PLANNING TECHNICAL REVIEW COMMITTEE –AGENDA

TECHNICAL REVIEW COMMITTEE MINUTES – P21-37

TO: Donna Benton, Planner, City of Dover **DATE:** 6/3/2021
FROM: Neil J. Rapoza, PE
CIVIL CONSULTANTS
SUBJECT: One First Street Redevelopment - TRC Response Memo
PROJECT: 20-279.00 One First Street, LLC (Dover project #P21-30)

PROPOSED SITE PLAN

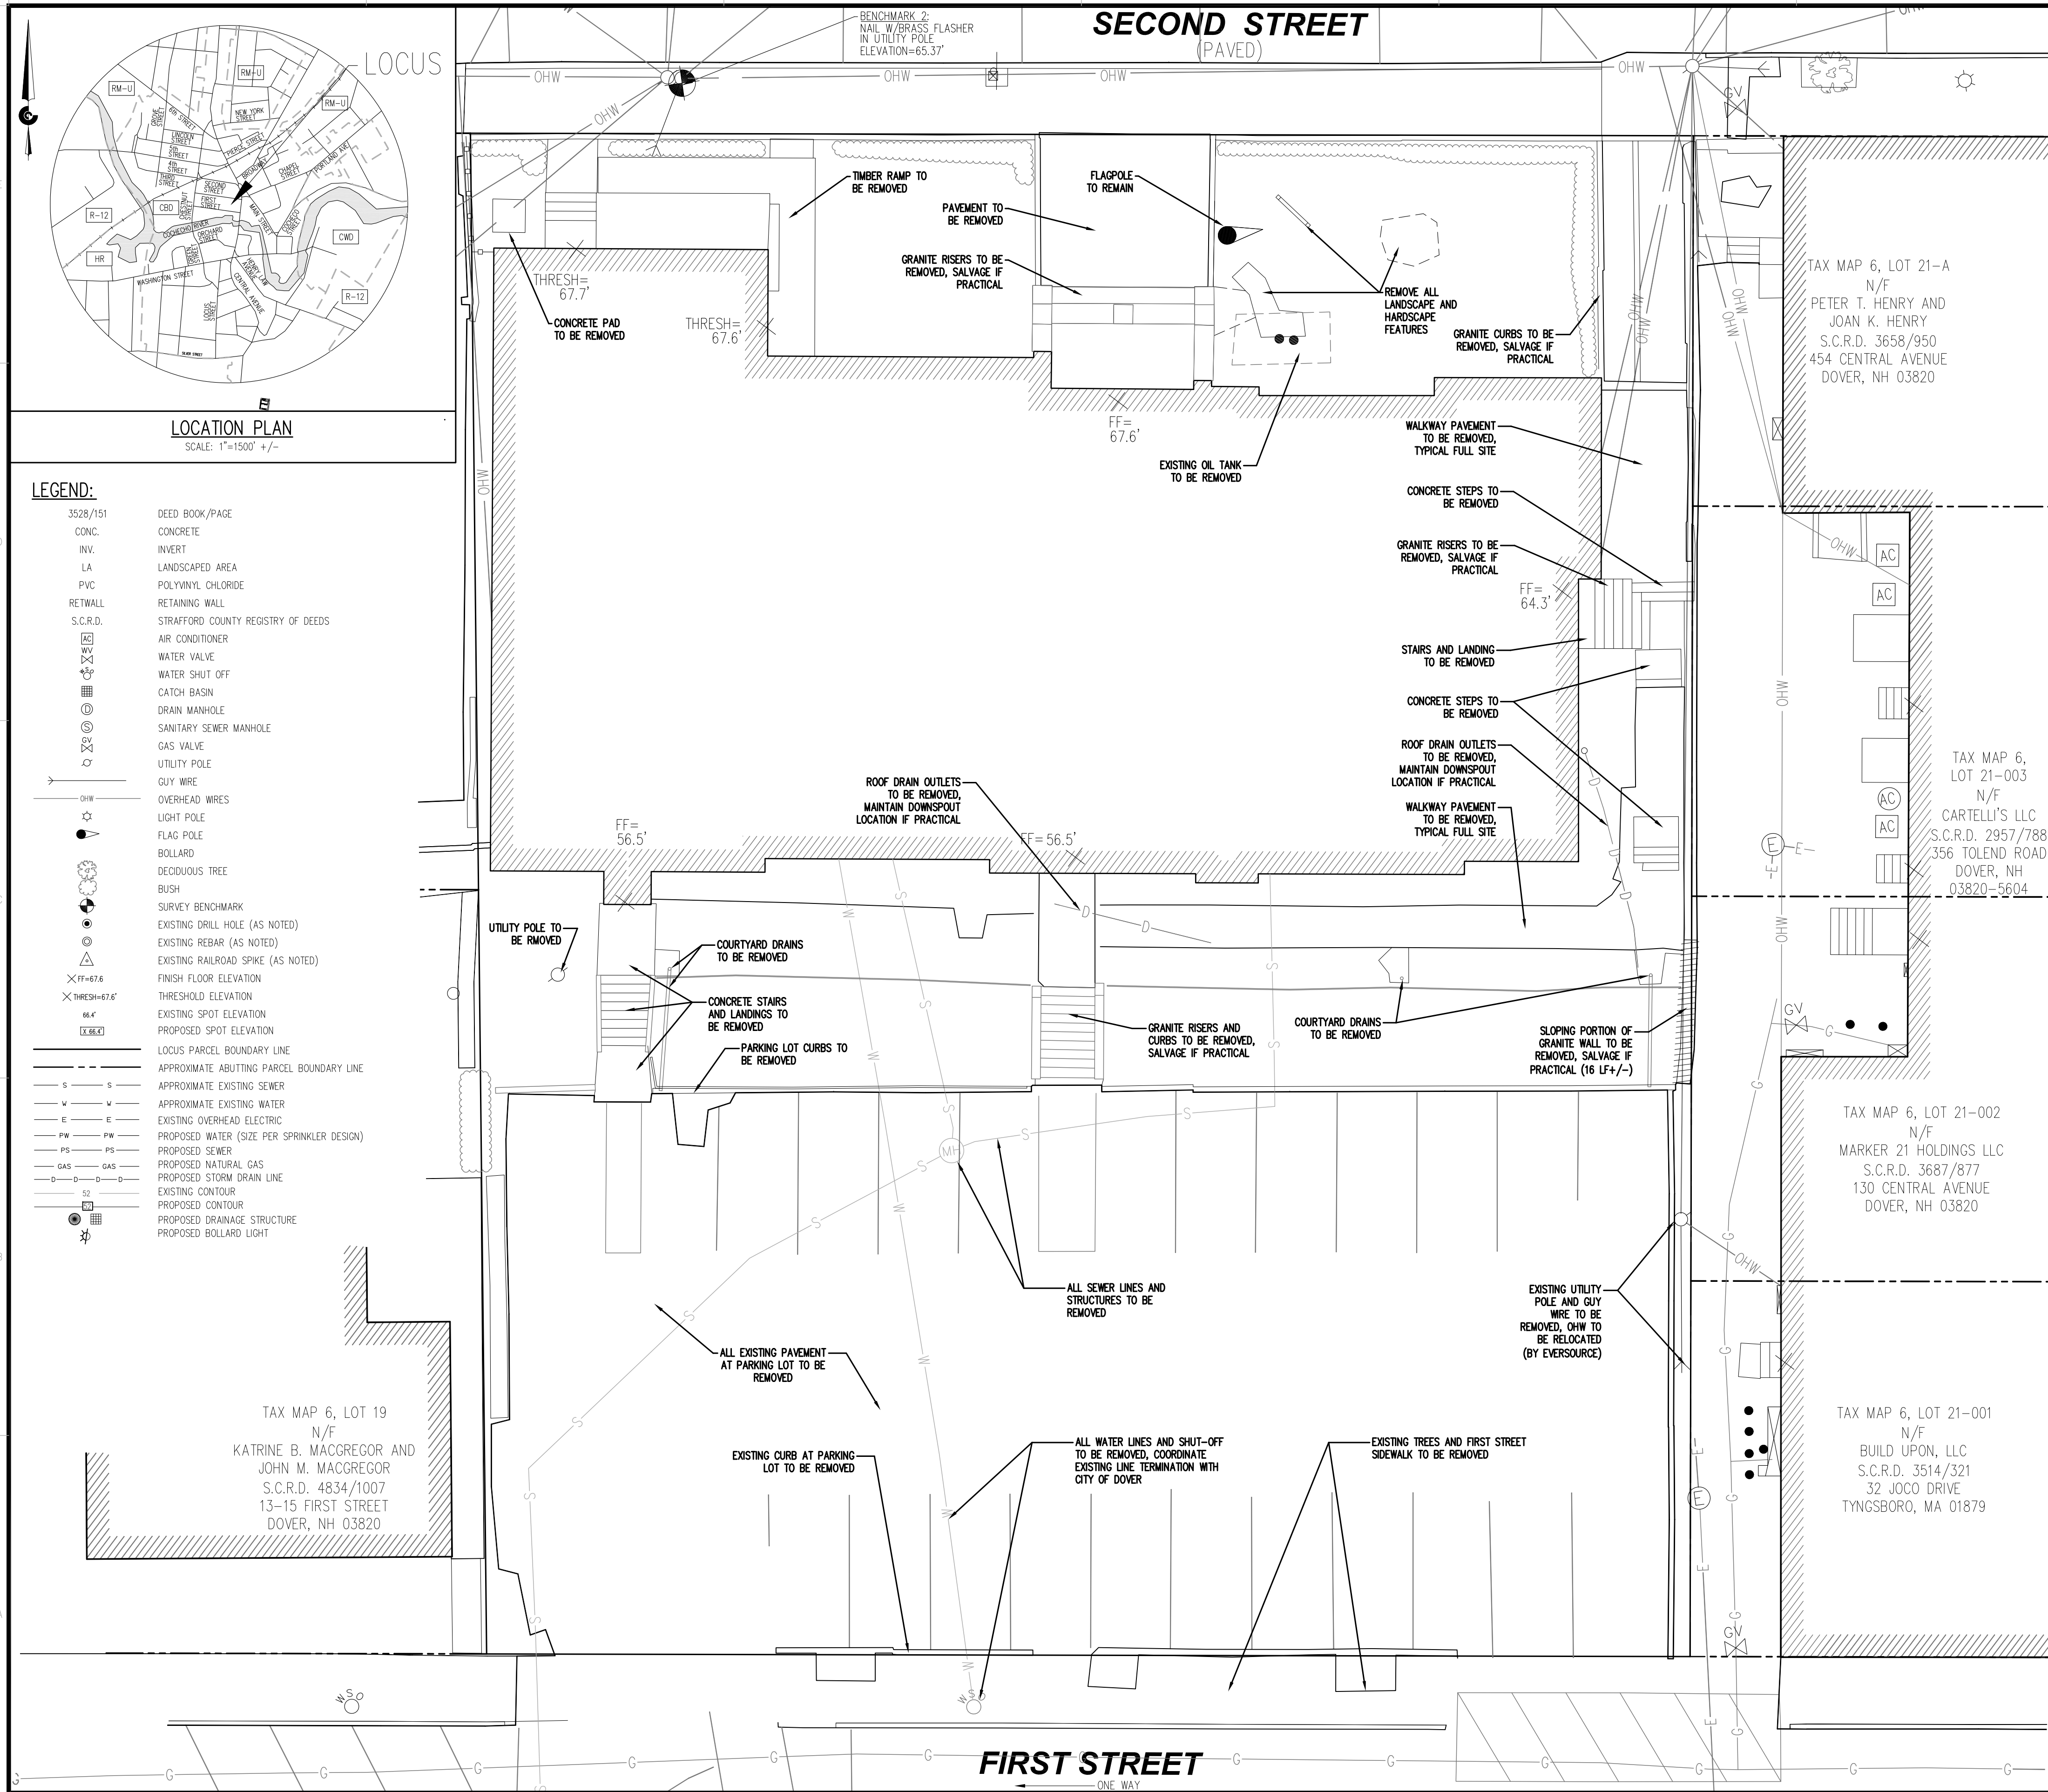
f) Update note 29 on sheet 4 to replace "paved" with brick, though loading zone are should remain concrete	<i>The note has been revised.</i>
g) Note the walkway between First and Second Street shall be concrete or brick not bituminous.	<i>This note has been added.</i>

h) Revise note 4 on sheet 4 to include the square footage	<i>The note has been revised.</i>
i) Add Common Site Plan Notes: 9,10, 12, 15, 16, 17, 18, 19, 20, 25, 26, 27, 28, 29, 30, 34, 40, and 41	<i>These notes have been added.</i>

PROPOSED
SECOND STREET
UTILITY PLAN

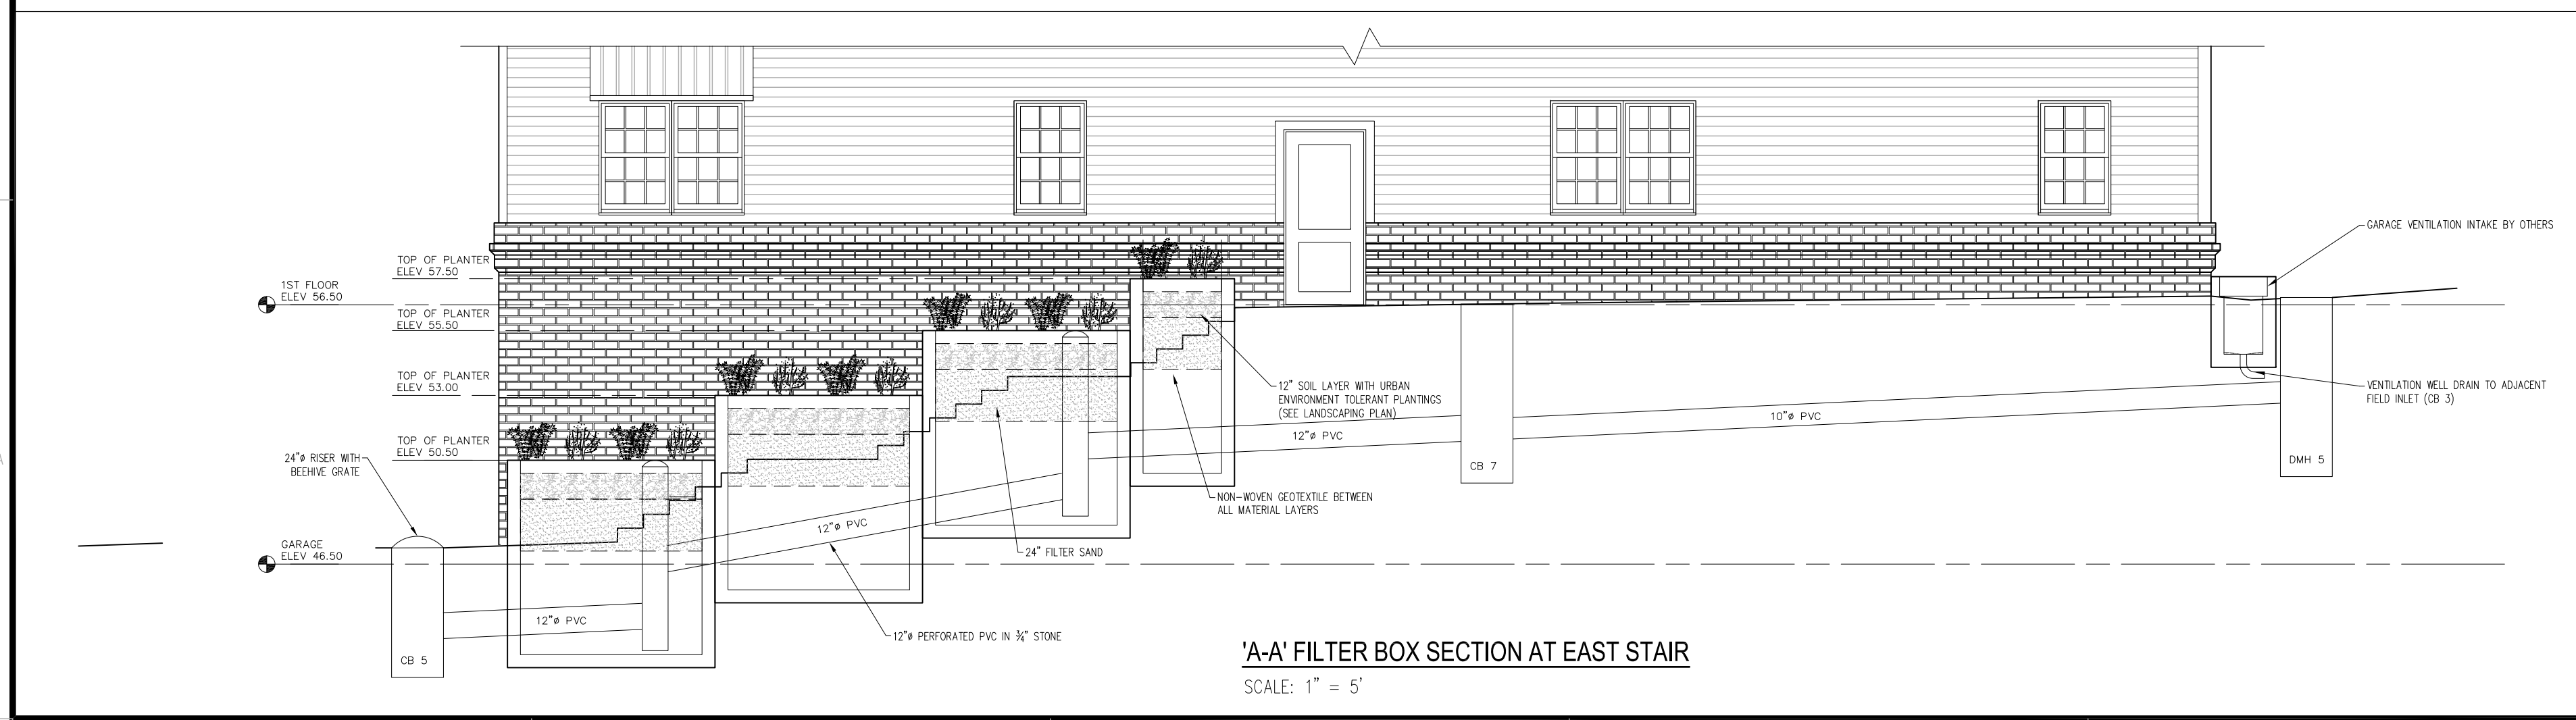
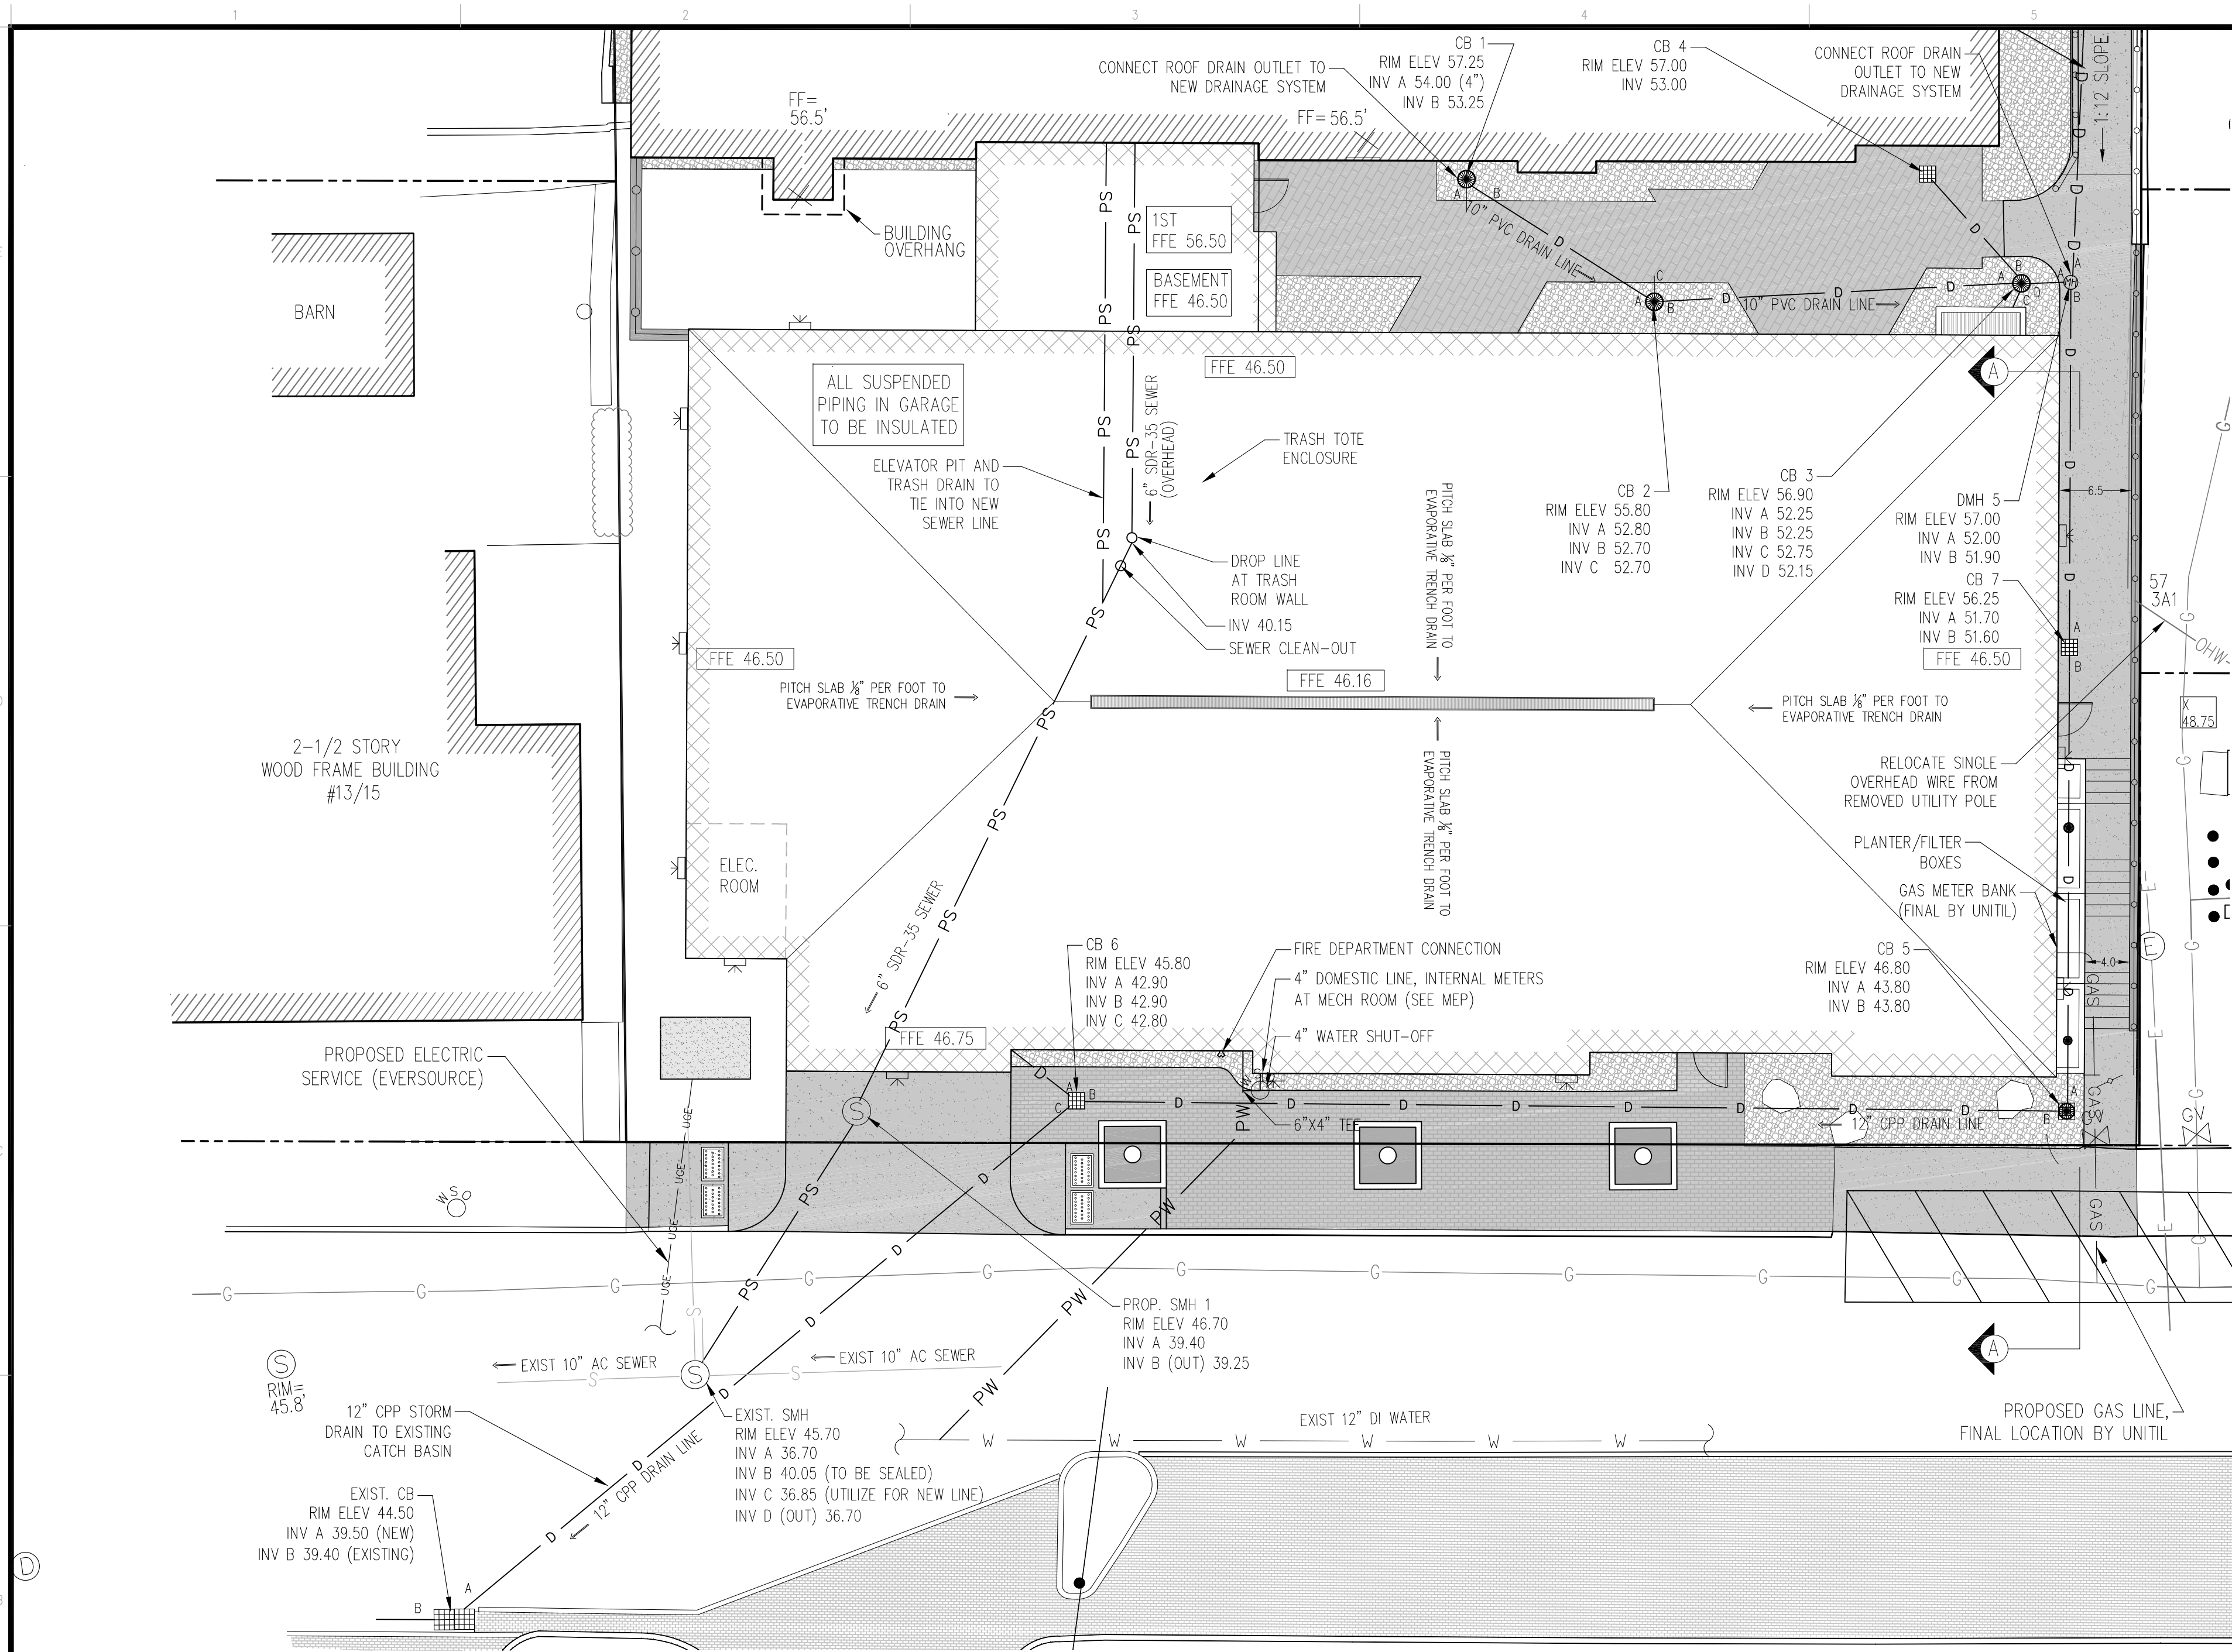
42. Edit Plan L4 note 8 referring to Maine solid waste and insert applicable NH and Dover language Chapter 145	<i>The notes have been removed from this sheet, all erosion control notes are now on sheet L6 with reference to Chapter 145.</i>
